Design Review Committee Meeting

Ms. Ardina Pierre has submitted an application seeking approval to demolish the existing home and reconstruct a new 2,622-square foot single-family dwelling with a detached garage at 817 Custer Street. The property is zoned V, Village and located within the Arts District Overlay.

**DEPARTMENT OF PLANNING AND ZONING
PLANNER'S REPORT**

DATE: September 3, 2020
TO: Tonya Hutson
FROM: Lynn Patterson
RE: **Design Review – 817 Custer St Revised**

**PROPOSED
DETACHED
GARAGE
PLANS &
ELEVATIONS**

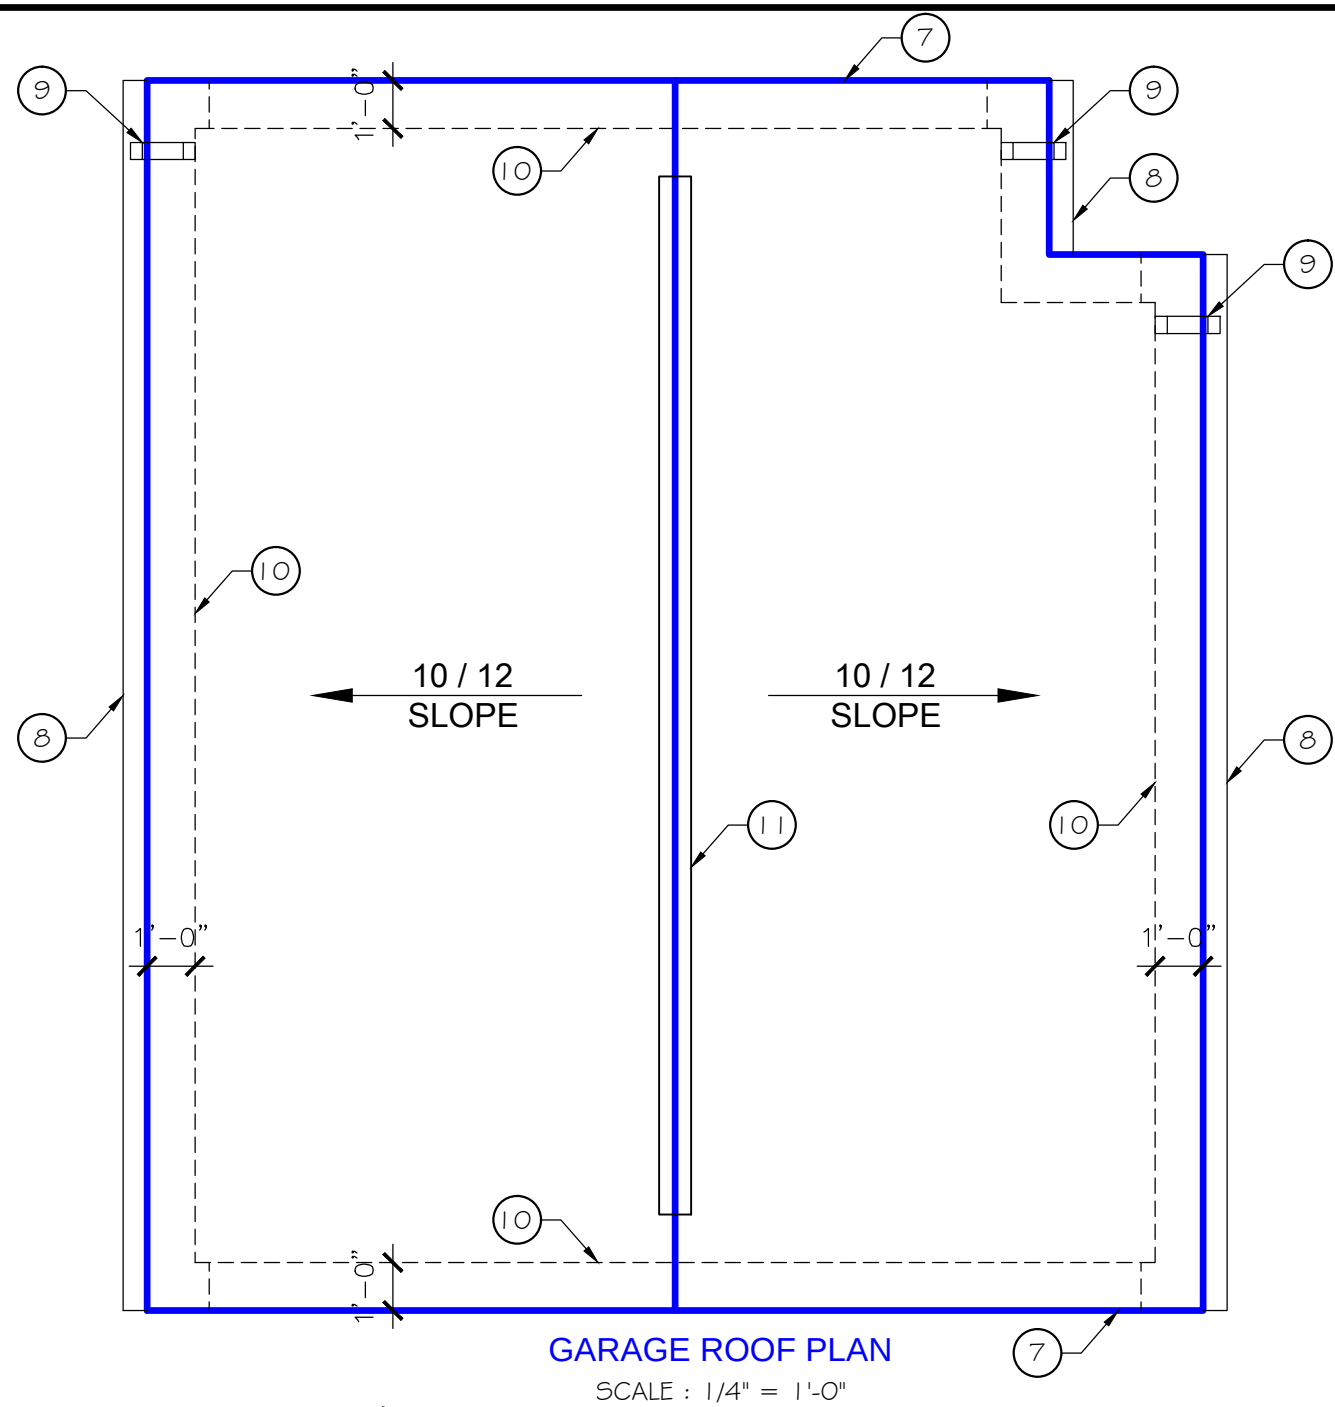
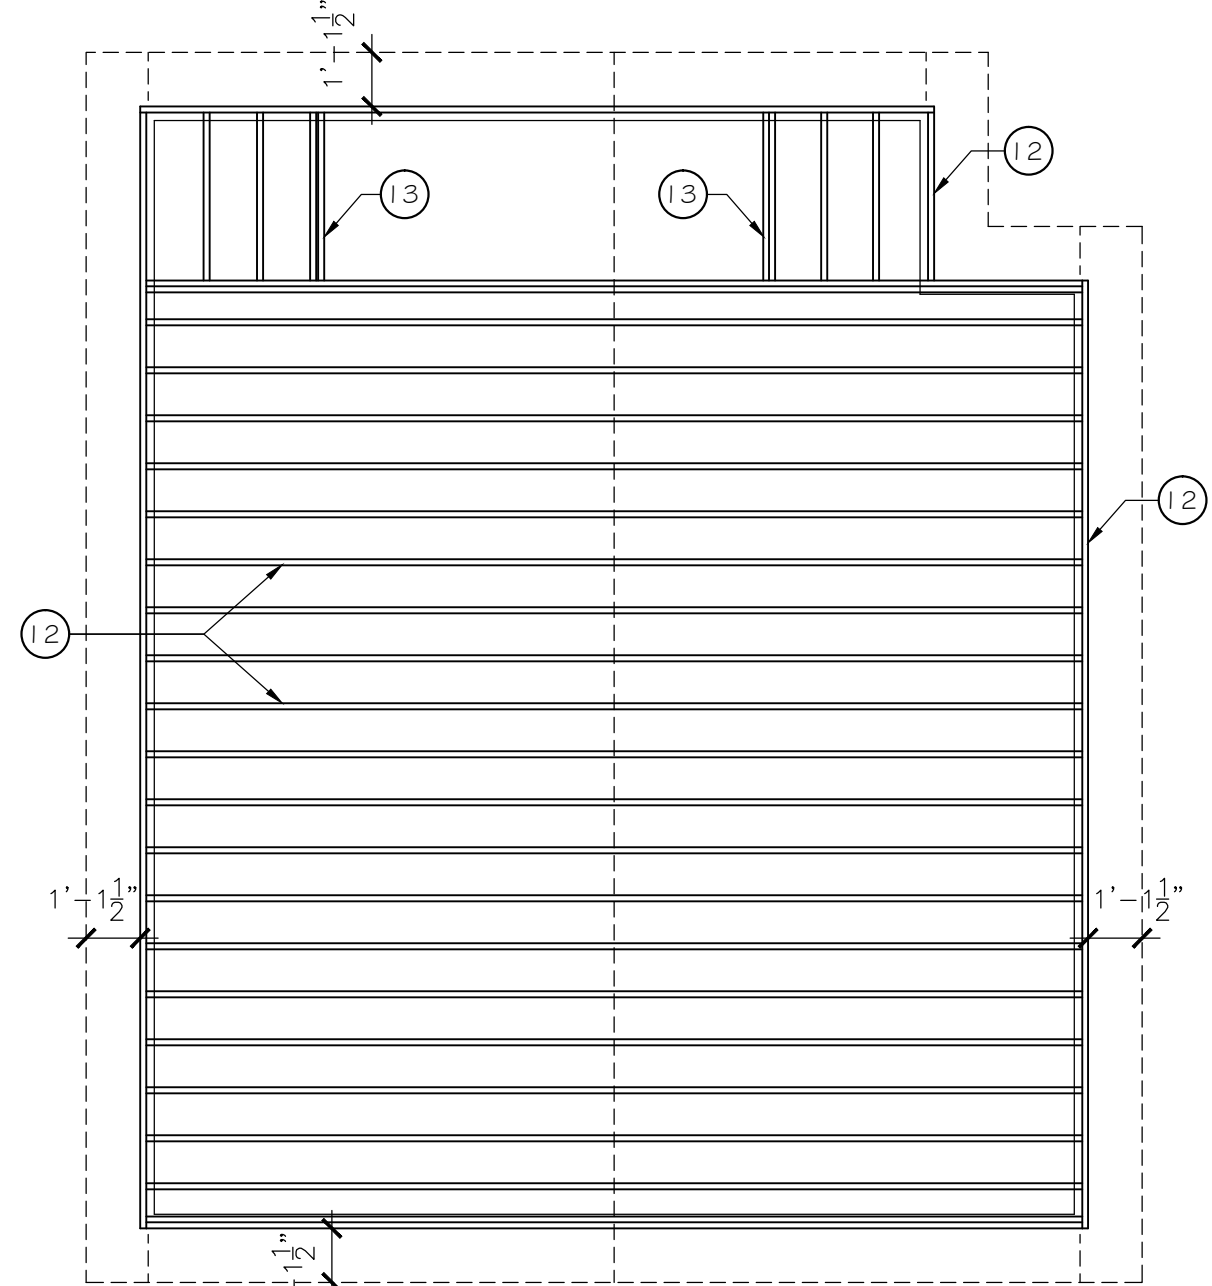
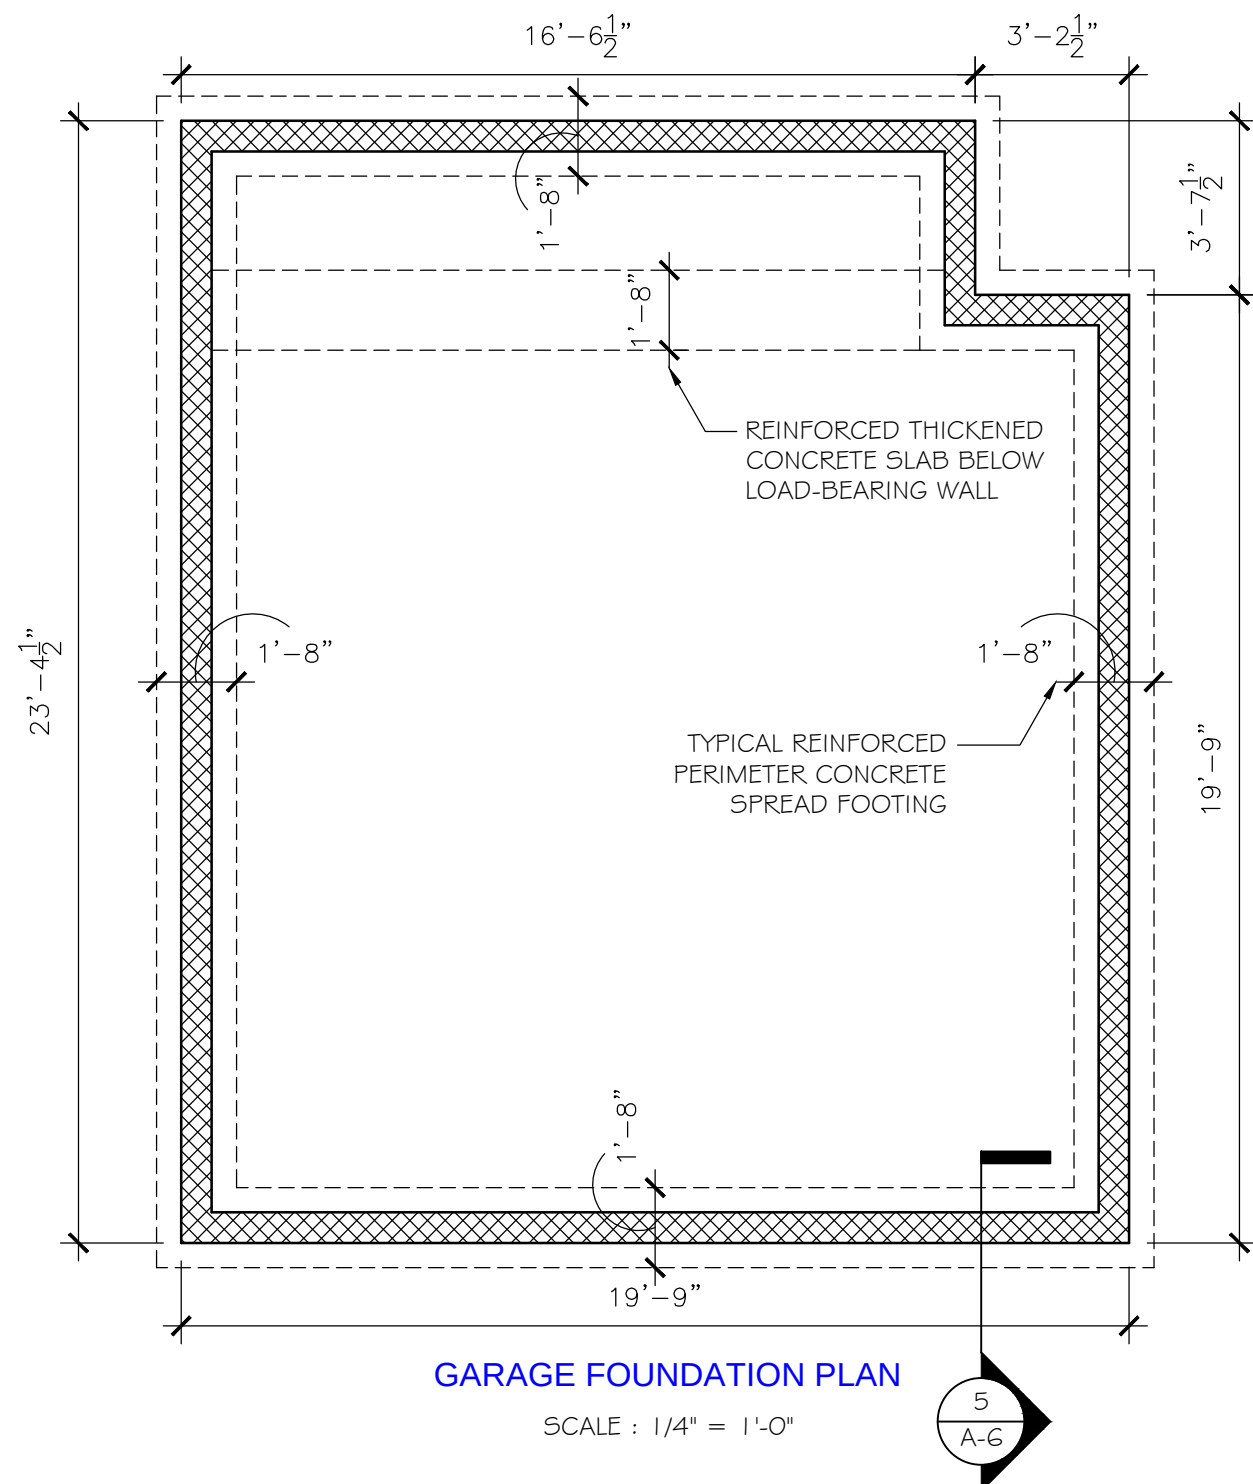
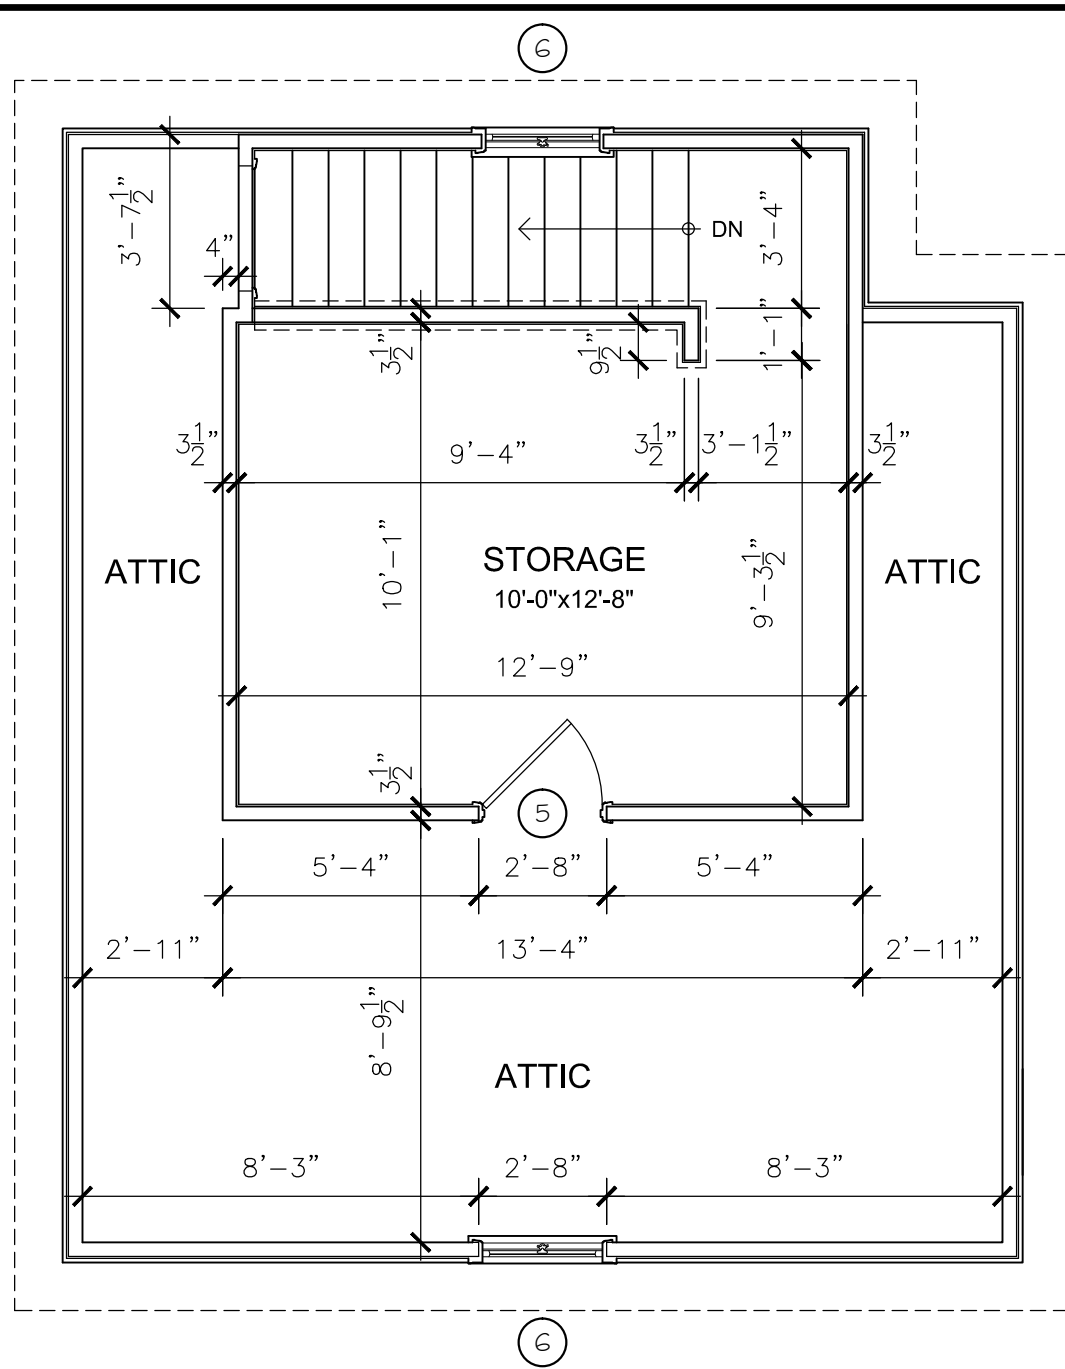
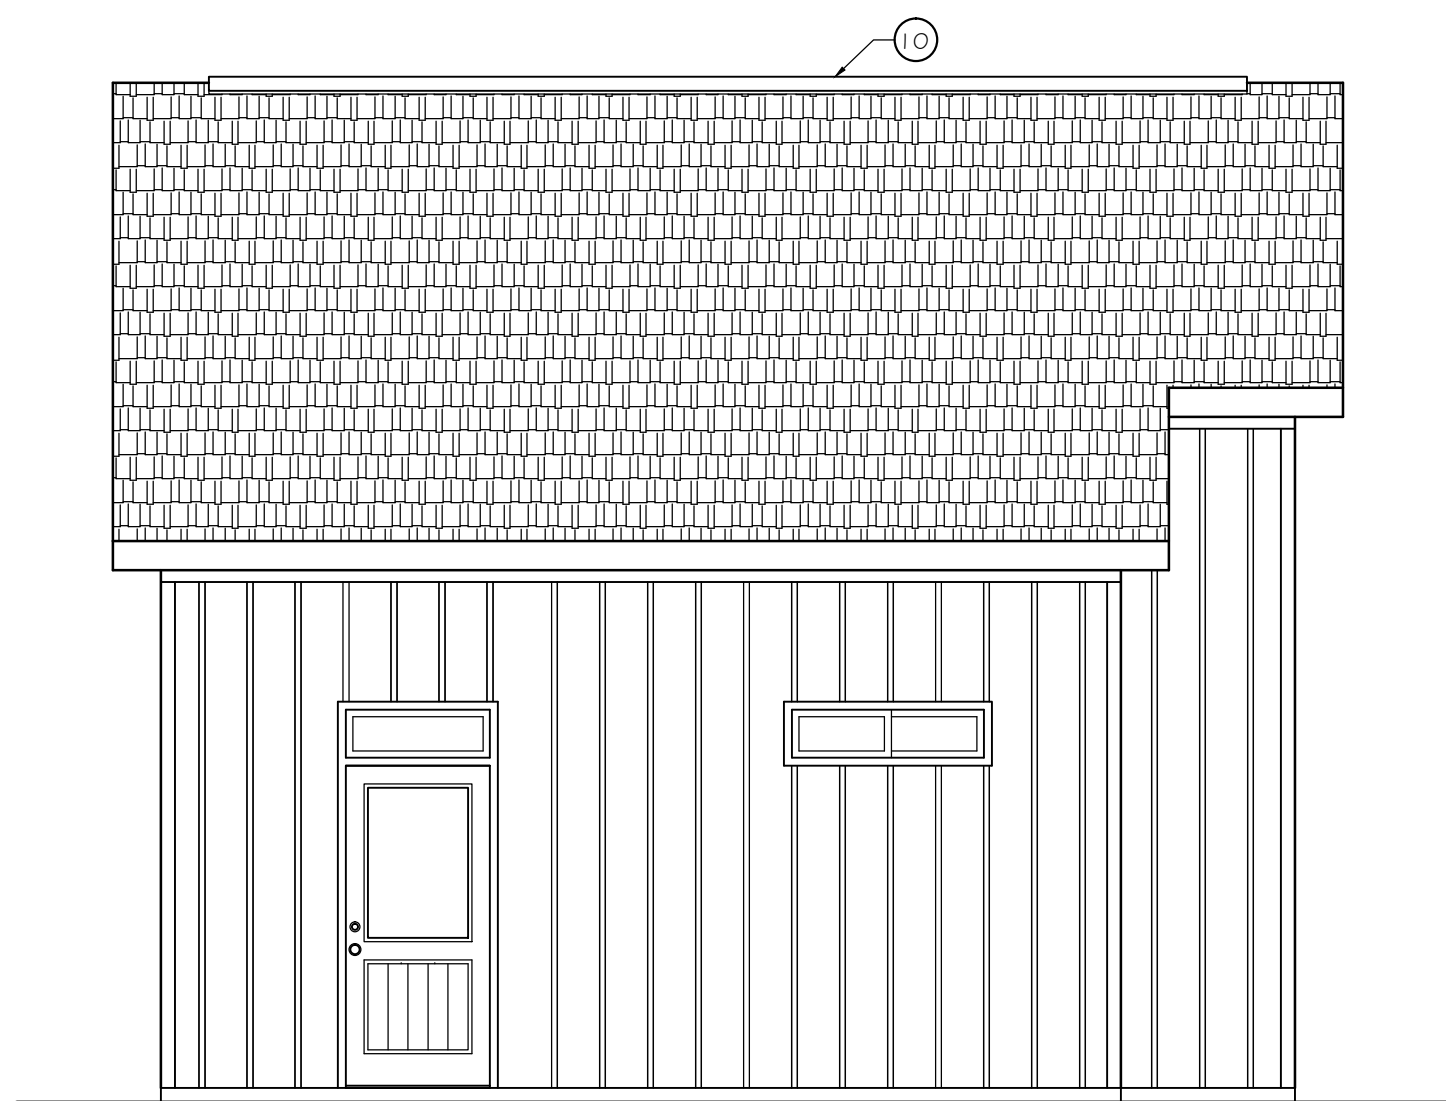
Ensure that the garage is not within 10' of neighboring shed.

- Ensure that each column is spaced a maximum of 8 feet from the center **Provided**
- Buildings numbers must be provided **Provided**
- Provide window dimensions to ensure that the window and door standards are being met, including recess. **Provided**
- Provide trim dimensions to ensure standards are met. Center mullions should be 2" wider than trim. **Provided**
- Provide sill information **Provided**
- Provide dimensions for sills above finished floor elevation. **Provided**
- Ensure that the garage is not within 10' of neighboring shed. **Provided**
